BOARD MEETING

AGENDA

WEDNESDAY, SEPTEMBER 2, 2026

Bucks County Planning Commission

LAND DEVELOPMENT PLAN

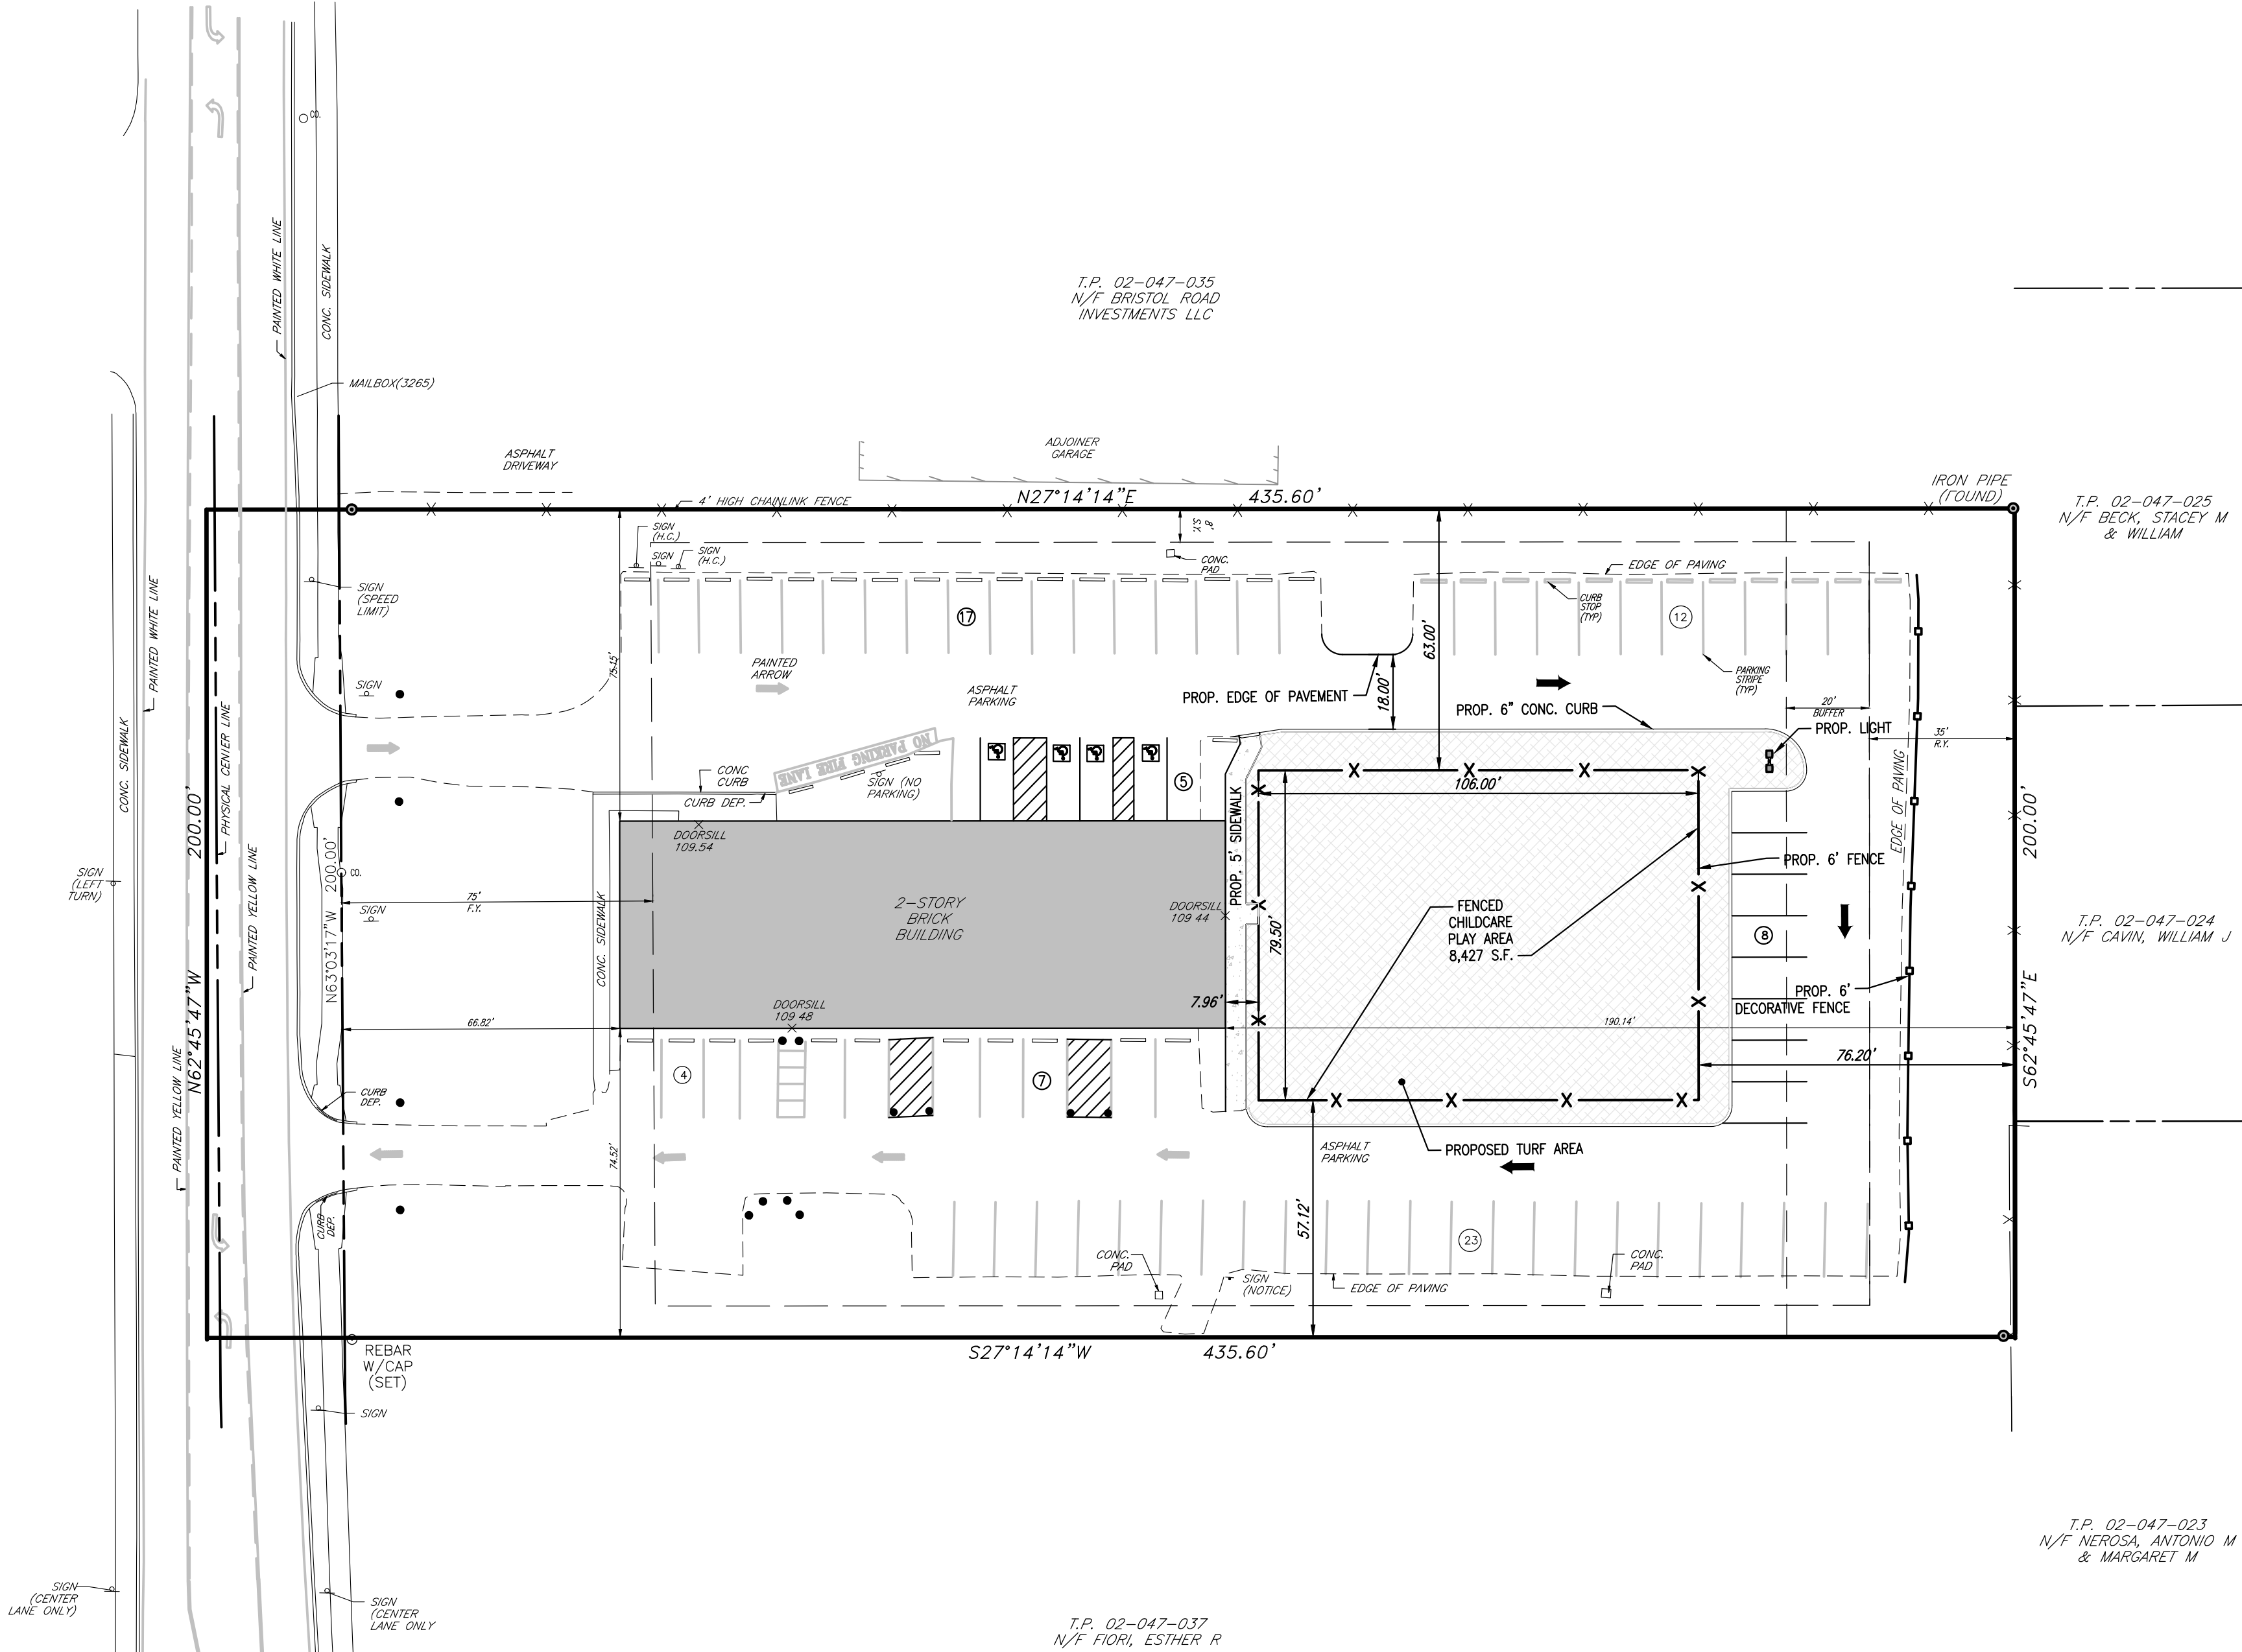
- Parking spaces**—The Parking Requirements table on Sheet 1 shows that 54 spaces are required based on parking standards for office and childcare uses. However, 76 spaces will remain after construction of the proposed playlot, which is almost 30 percent more than required for the proposed uses. If it is determined that not all 76 spaces are necessary for the intended businesses, we recommend the applicant consider providing fewer spaces. Reducing the impervious surface on the site will help lower maintenance costs and reduce stormwater runoff.

5. **Landscaping**
 - a. **Landscape plan**—Section 201-106.(c)(9) of the SALDO requires that a landscape plan be submitted for all land developments. Proposed landscape information is included on Sheet 3, Construction & Sediment Control Plan. We recommend the required landscape plan be prepared, signed, and sealed by a registered landscape architect licensed in the state of Pennsylvania.

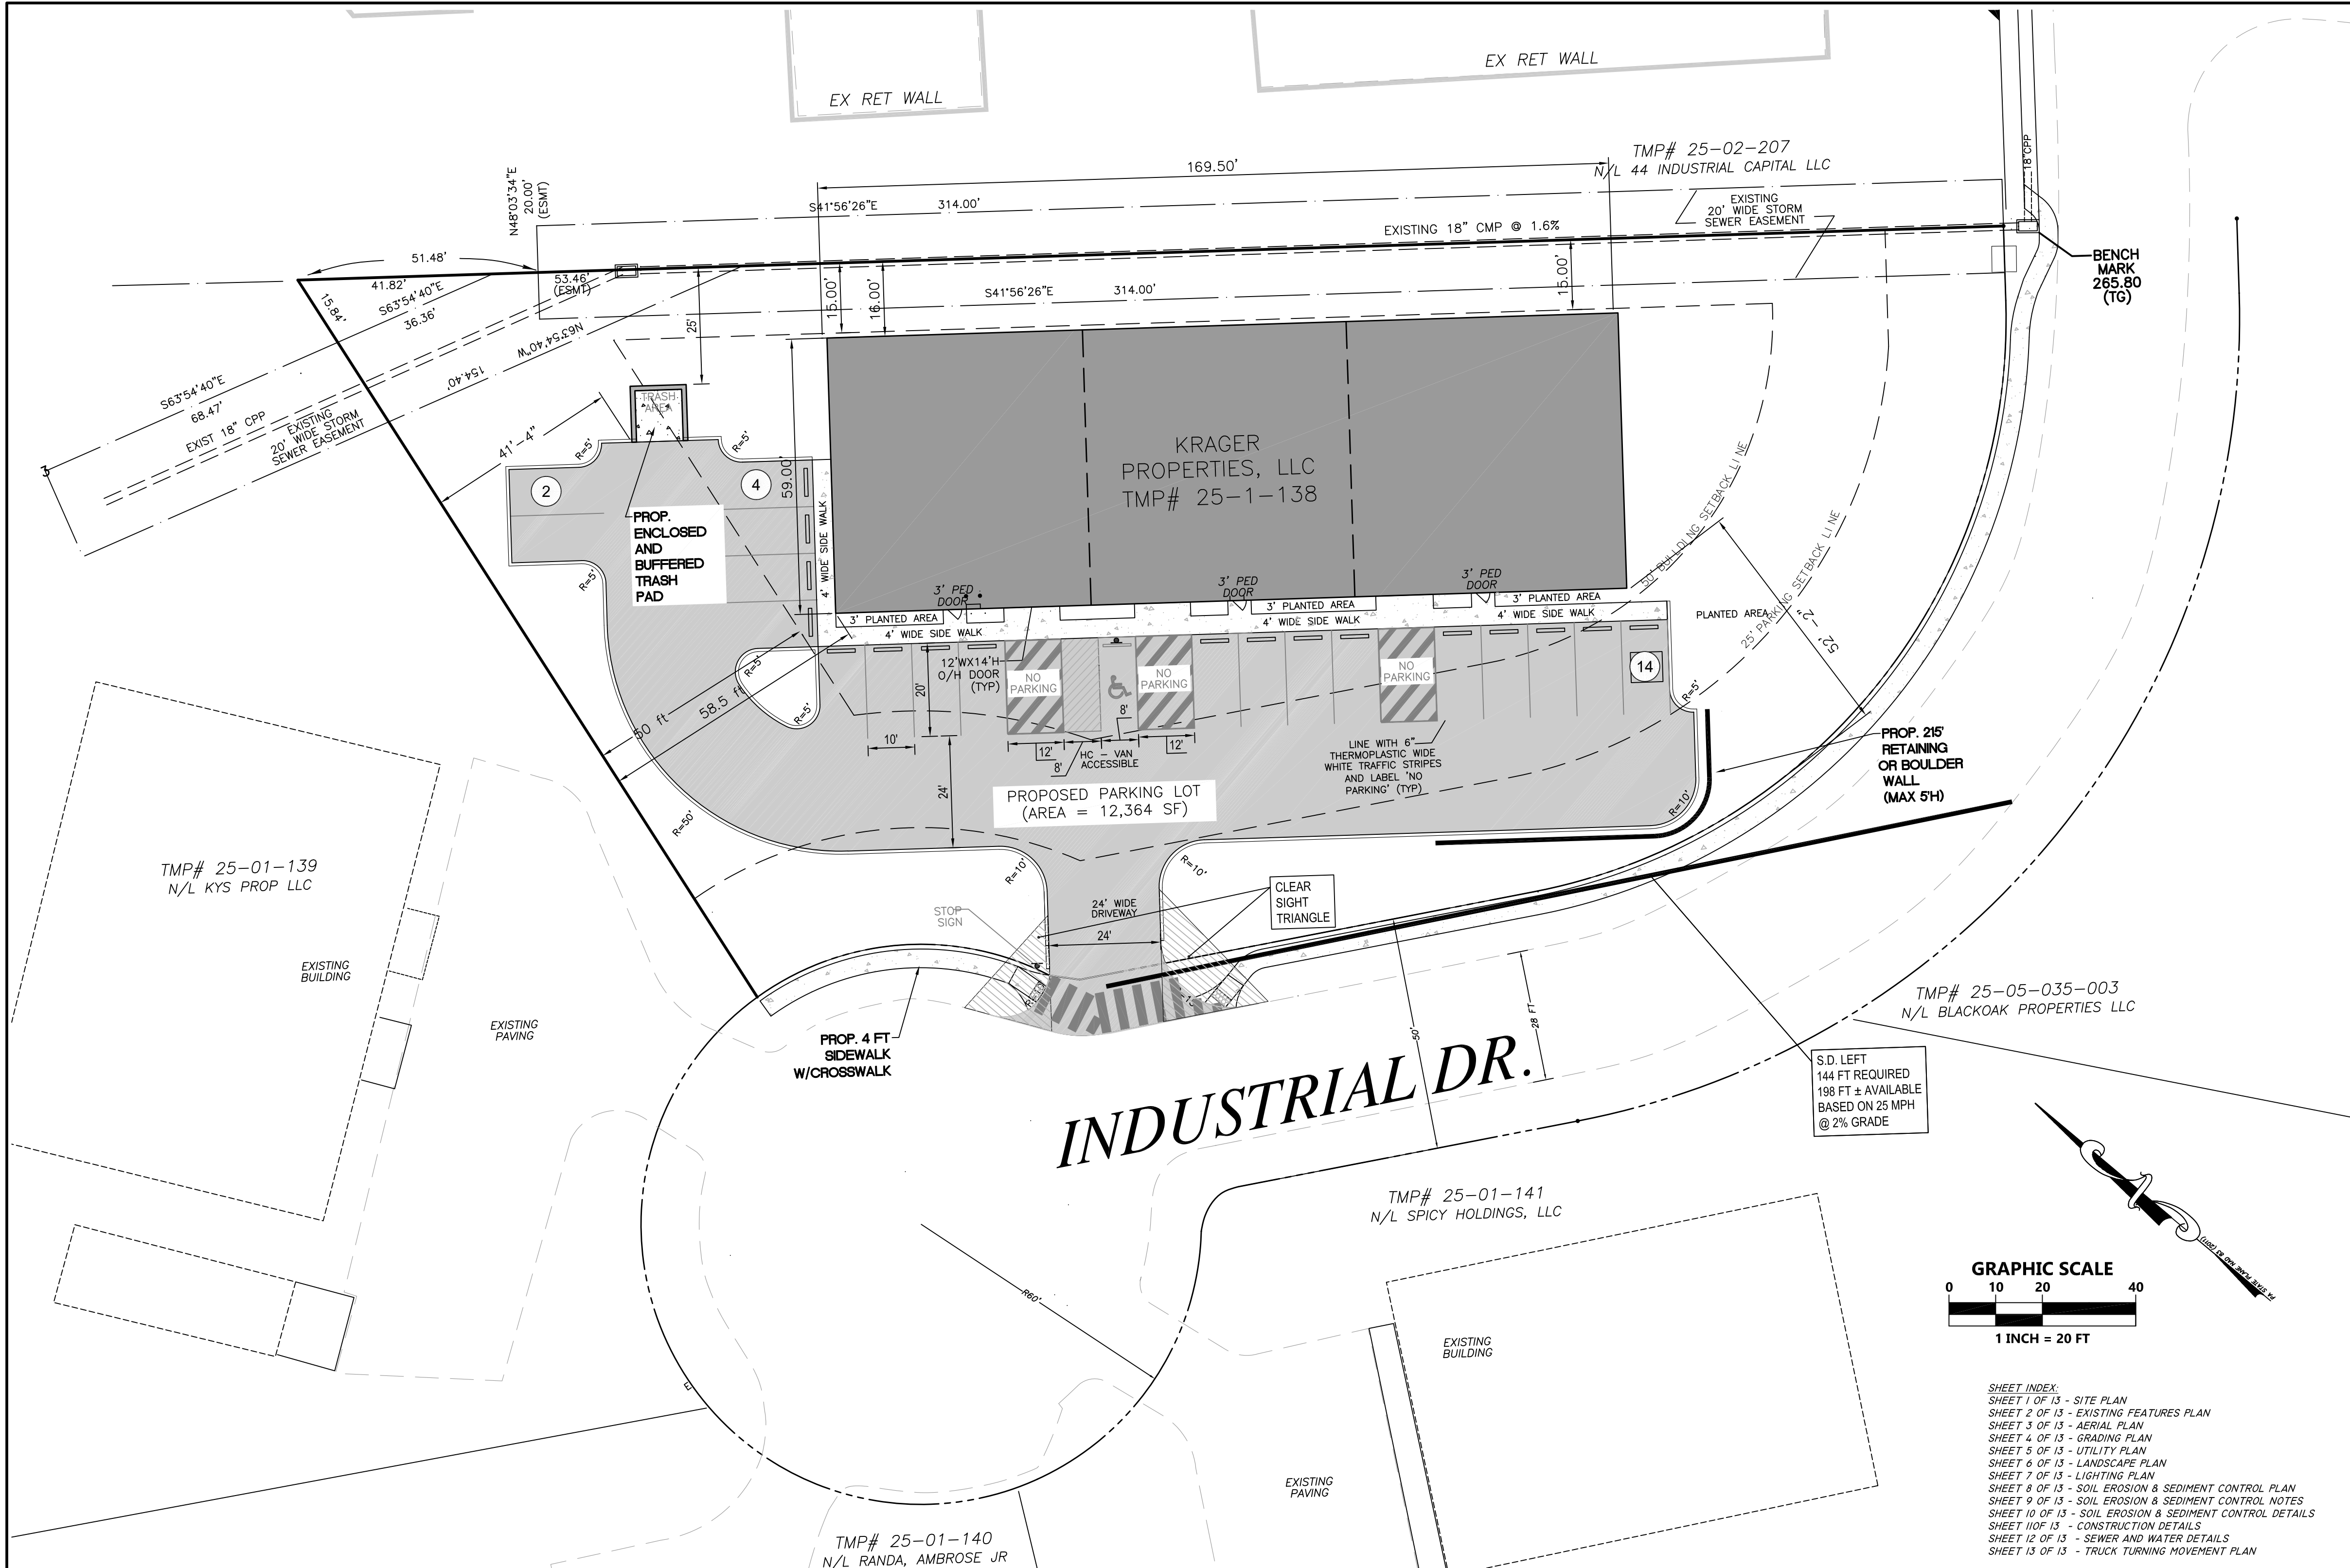
3. **Parking area layout**—The parking spaces located closest to the site driveway may create conflicts between vehicles backing out of the spaces and vehicles entering or exiting the site. We recommend that the applicant explore alternative parking area layouts to address this potential conflict.

4. **Site circulation**—The applicant should confirm that the SU-30 design vehicle (single-unit truck), as shown on Sheet 13, represents the largest vehicle anticipated to access the site. If larger vehicles are anticipated, turning movement templates should be provided demonstrating that the site can adequately accommodate those vehicles.
